MASTER DEVELOPMENT DRAINAGE PLAN

Tract C

**CLAREMONT COMMERCIAL
SUBDIVISION FILING NO. 2**

EL PASO COUNTY, COLORADO

Detention Basin Outlet Structure Design

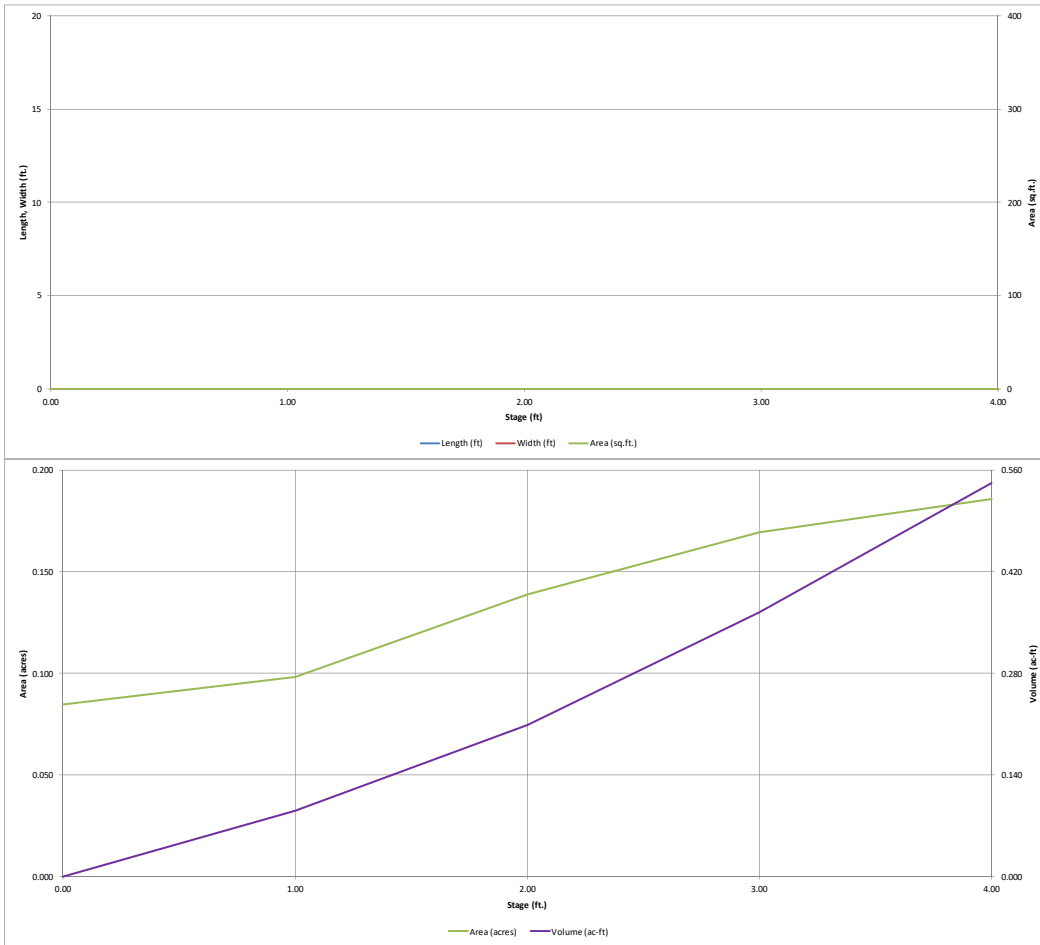
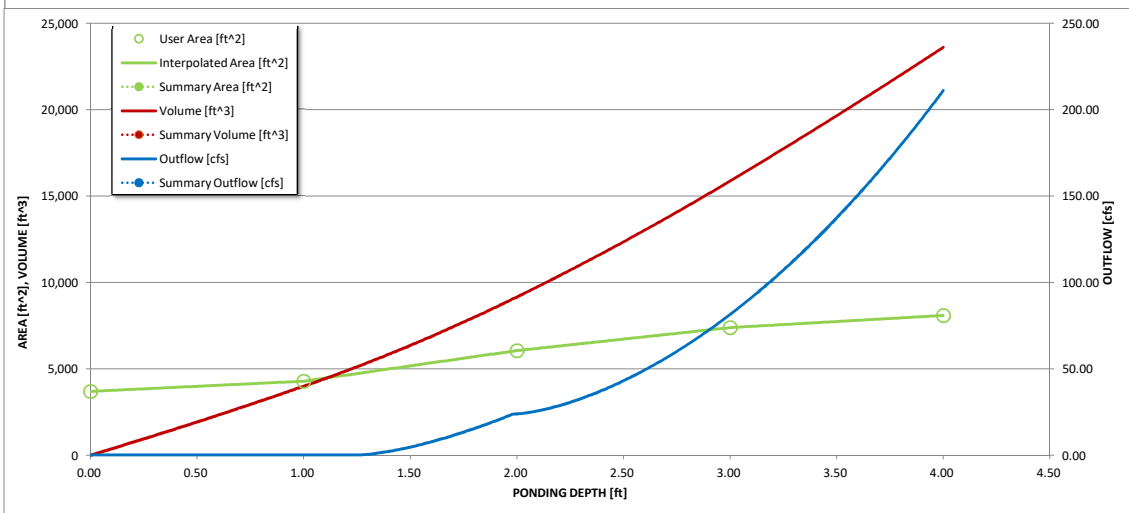
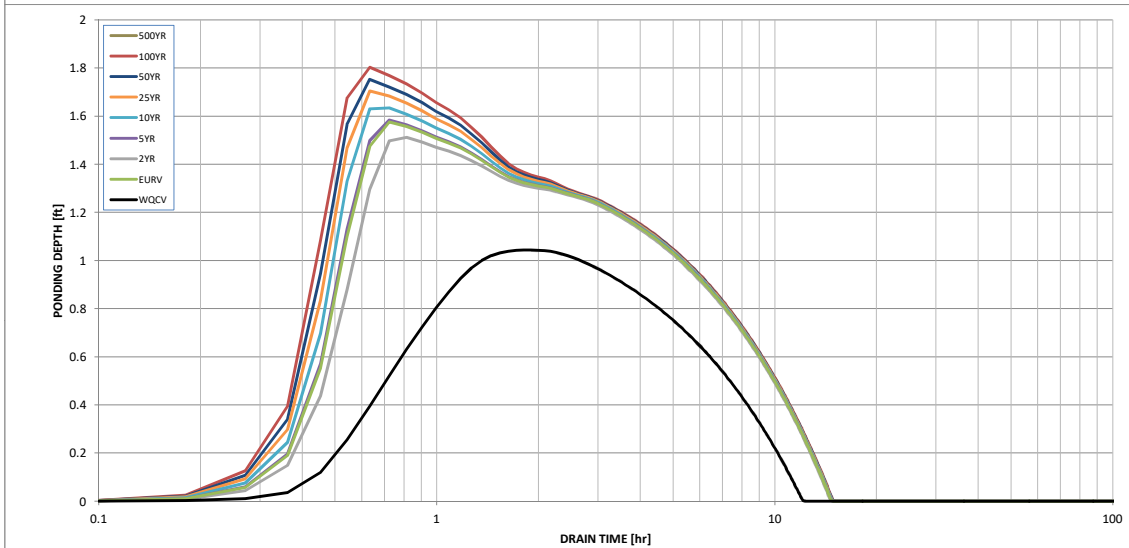
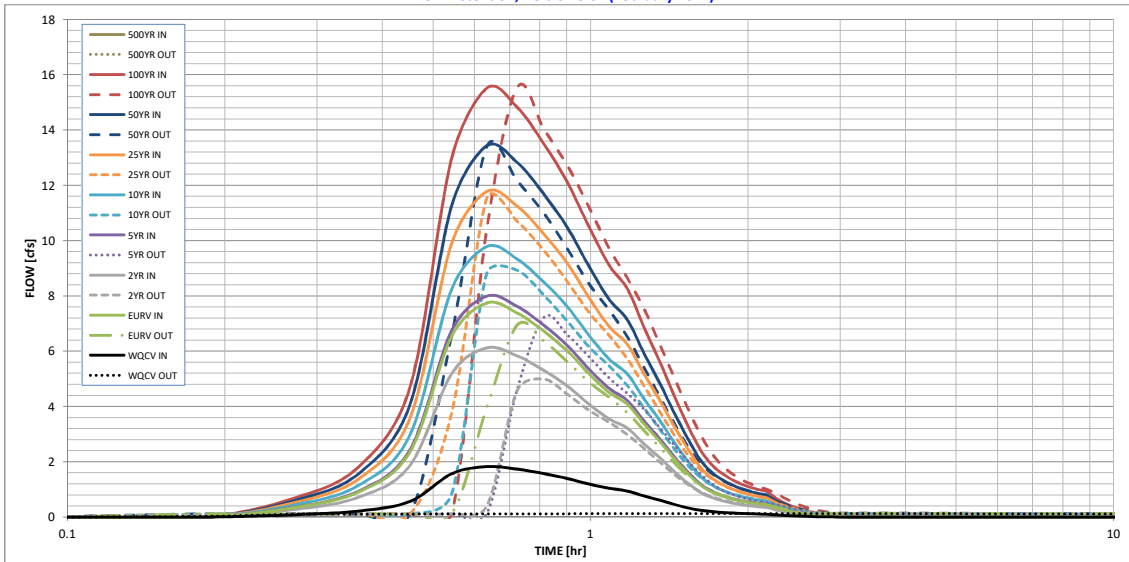
*Provide note indicating that per resolution 16-426 of the BoCC, on-site WQCV is required but on-site stormwater detention is not required per the FDR for Claremont Business Park Fil. 2. This has been requested on previous projects you've done in this area.

Detention Basin Outlet Structure Design

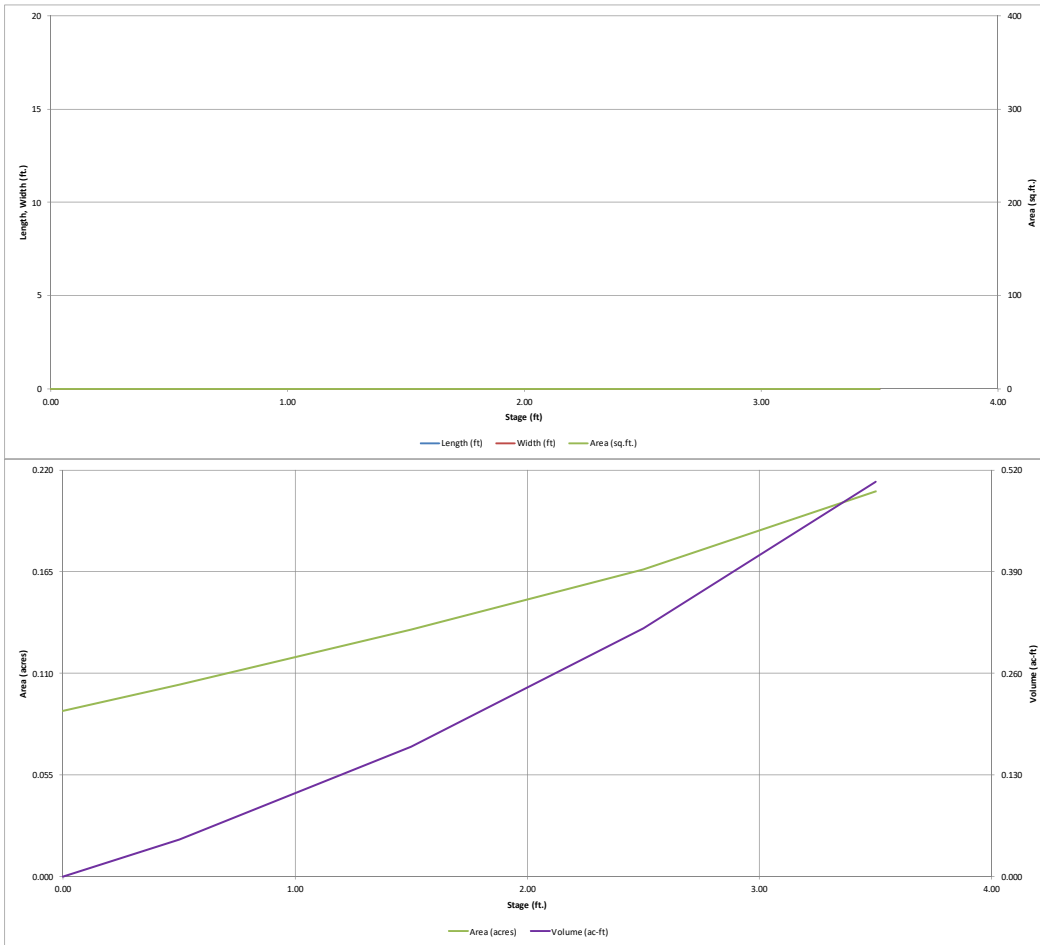
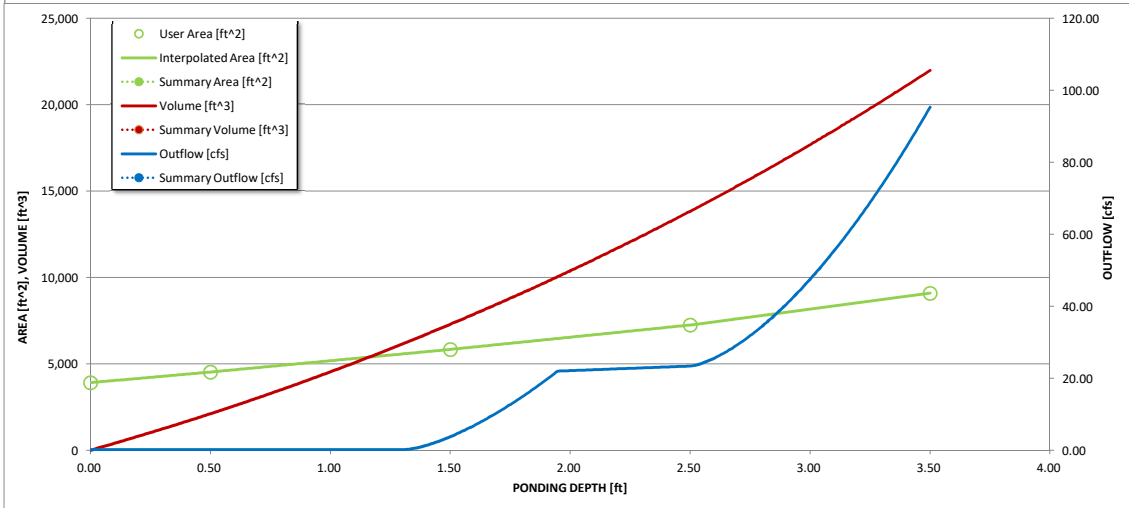
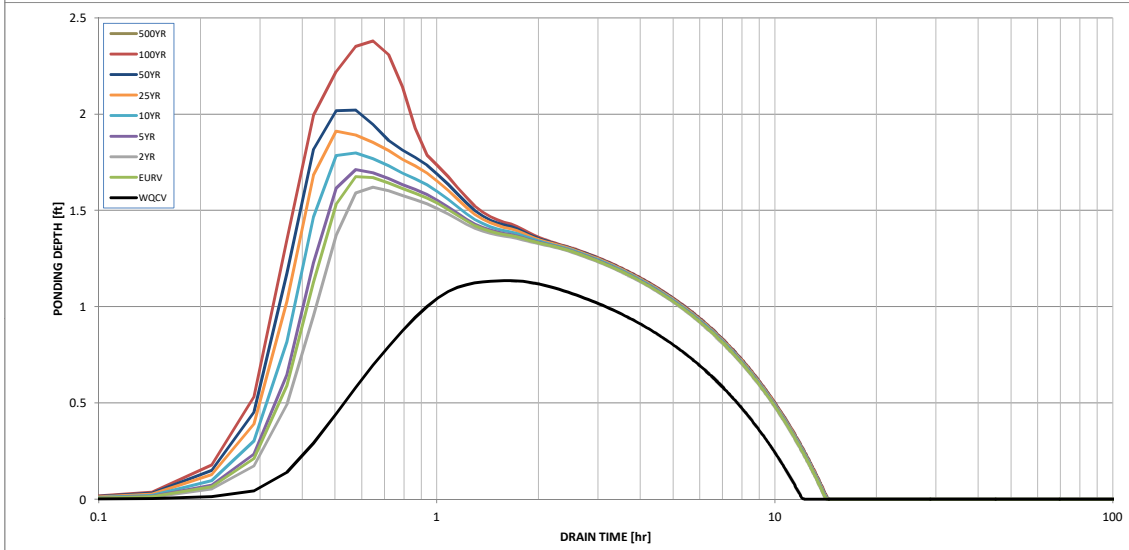
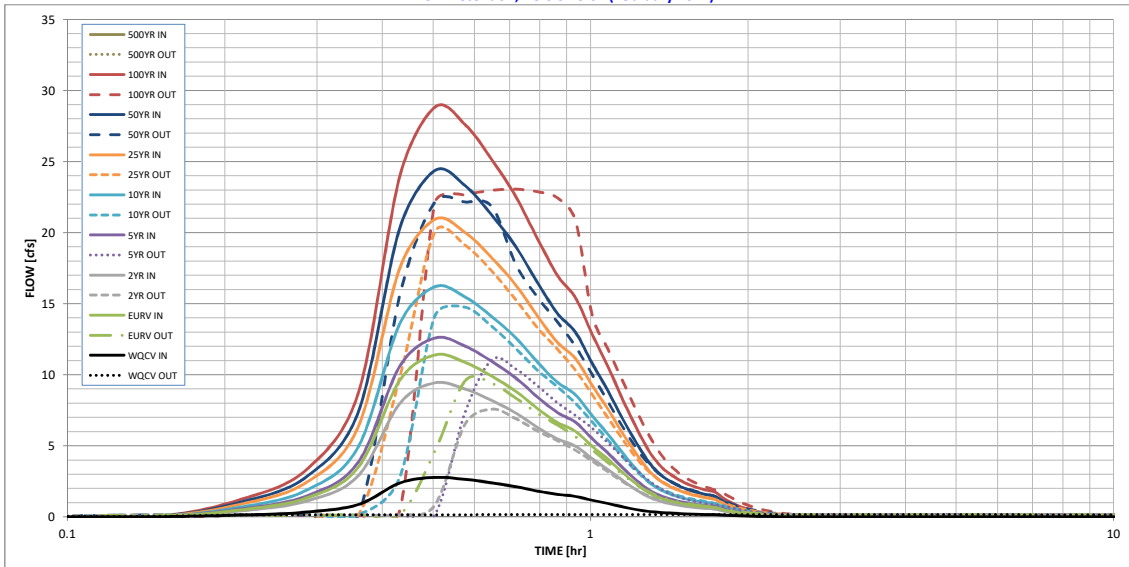
*Provide note indicating that per resolution 16-426 of the BoCC, on-site WQCV is required but on-site stormwater detention is not required per the FDR for Claremont Business Park Fil. 2. This has been requested on previous projects you've done in this area.

MASTER DEVELOPMENT DRAINAGE PLAN

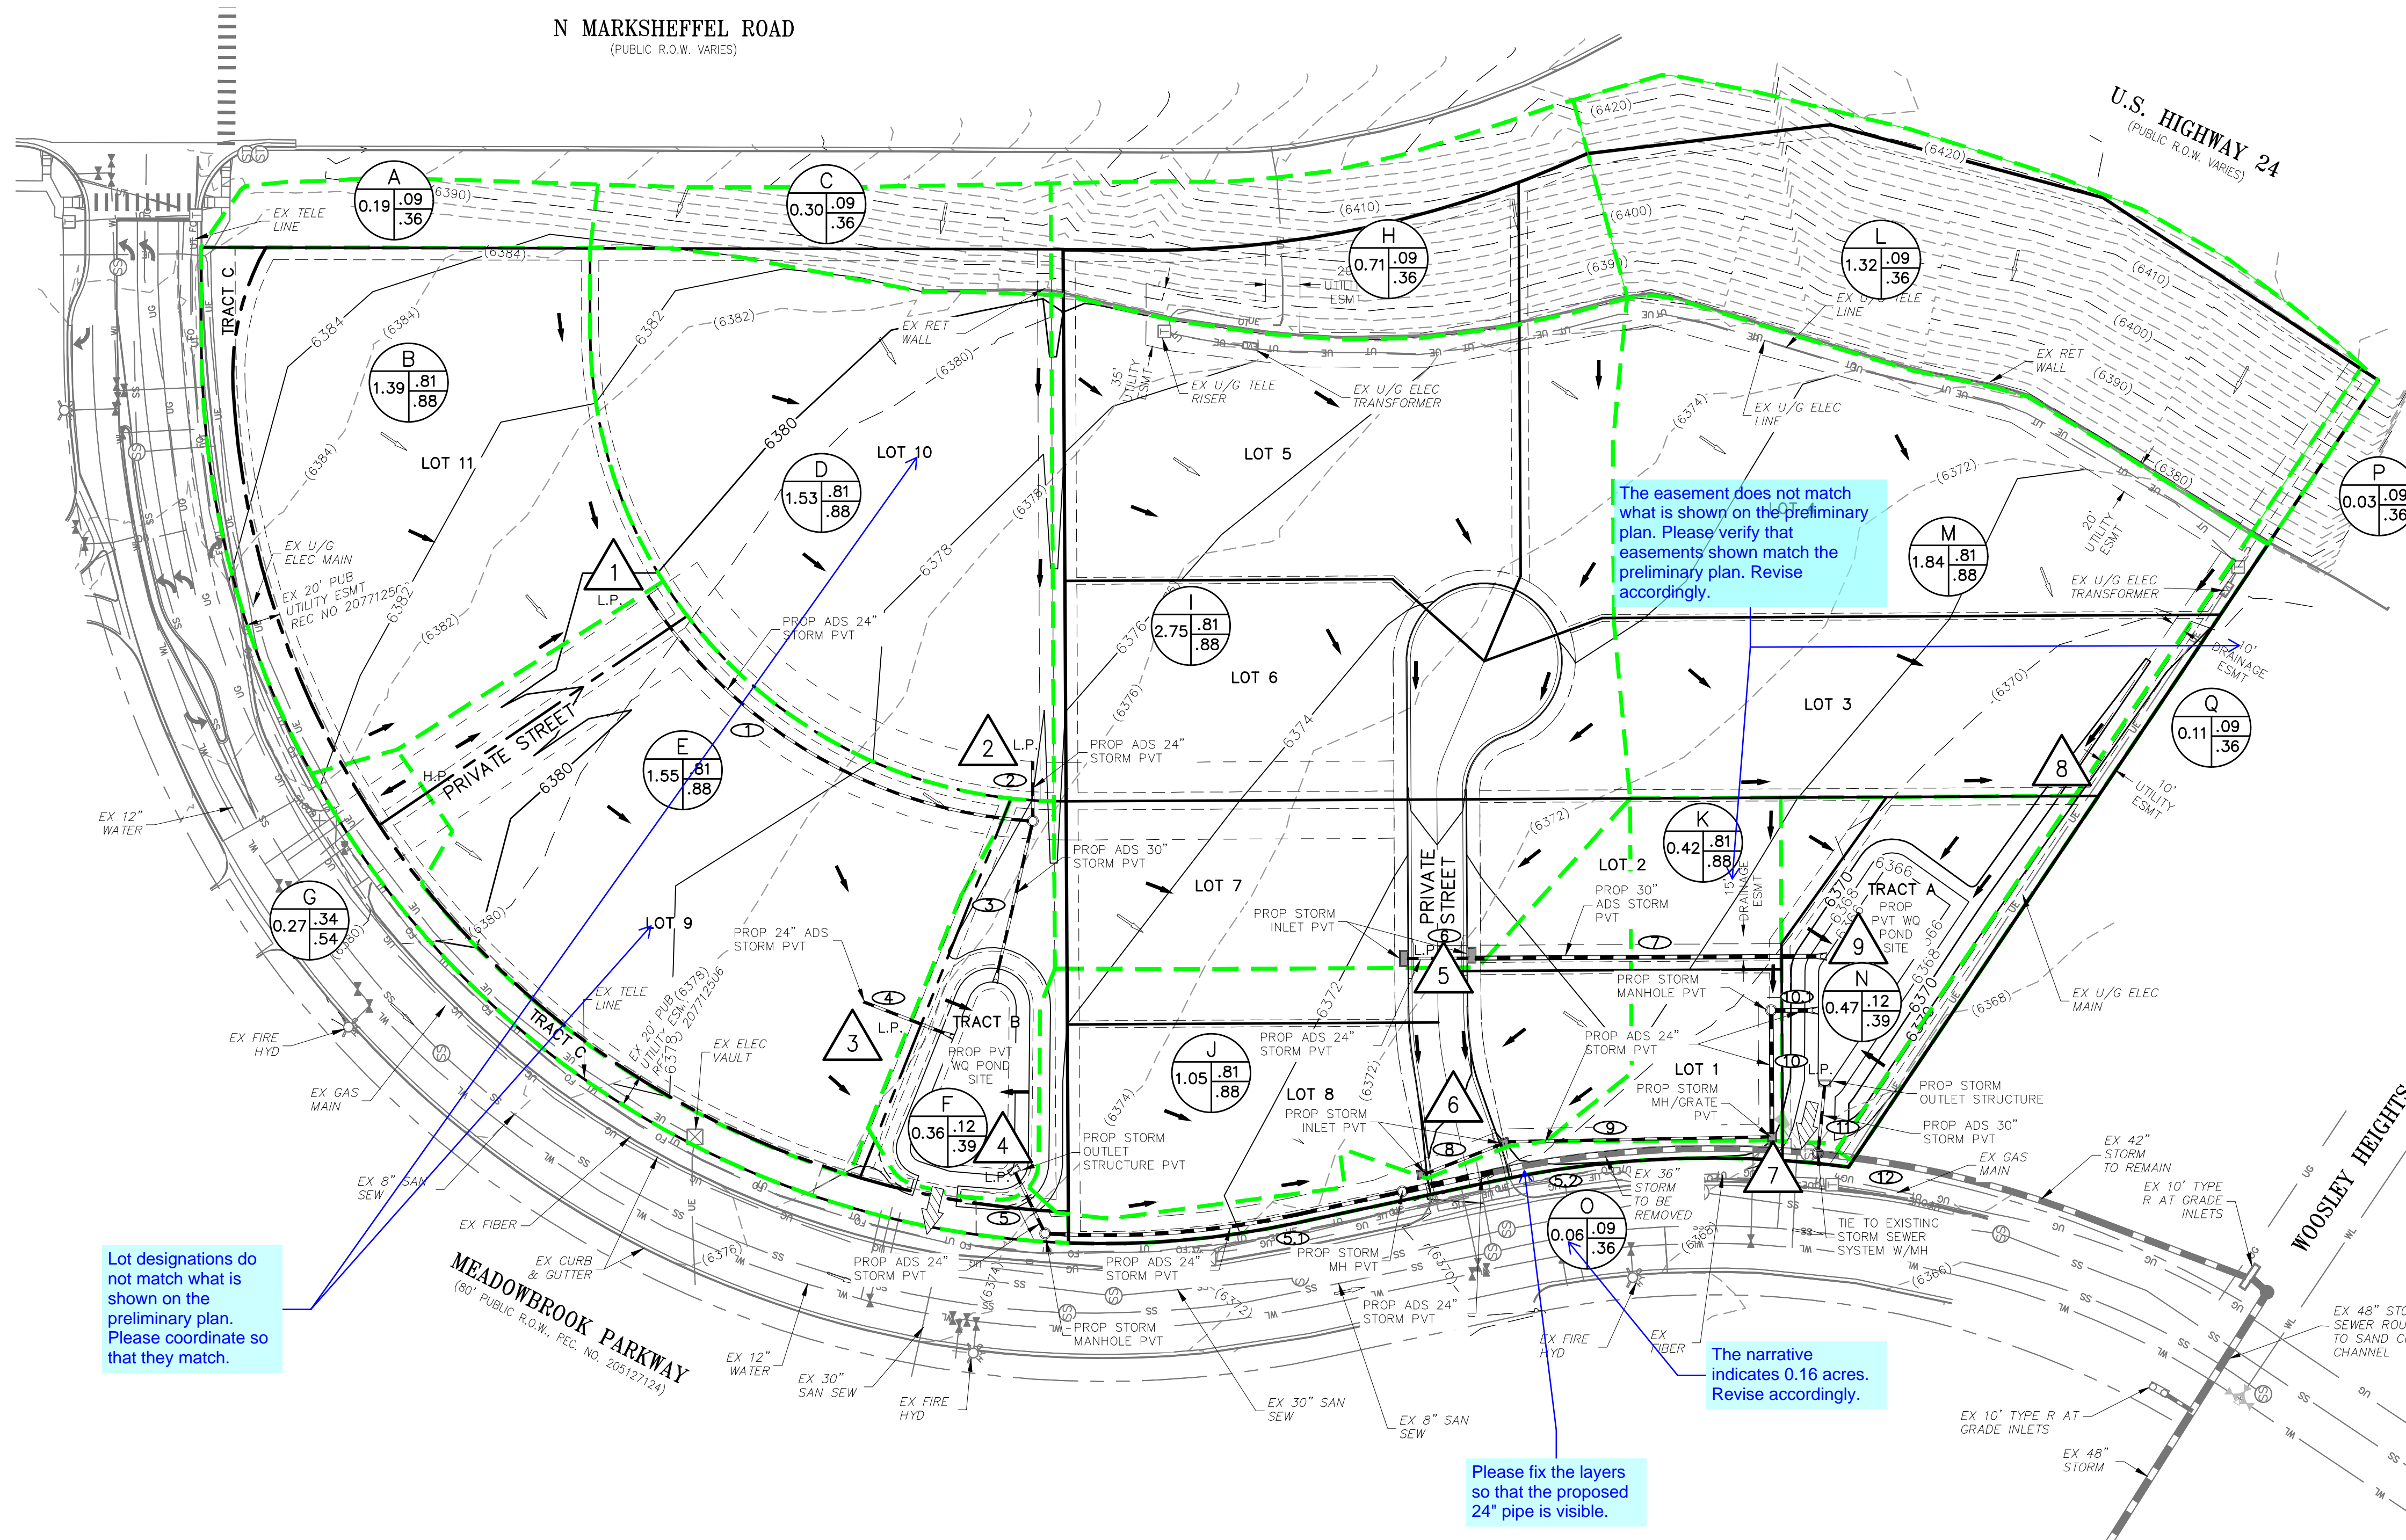
Revise title accordingly.

The easement does not match what is shown on the preliminary plan. Please verify that easements shown match the preliminary plan. Revise accordingly.

The narrative indicates 0.16 acres. Revise accordingly.

Lot designations do not match what is shown on the preliminary plan. Please coordinate so that they match.
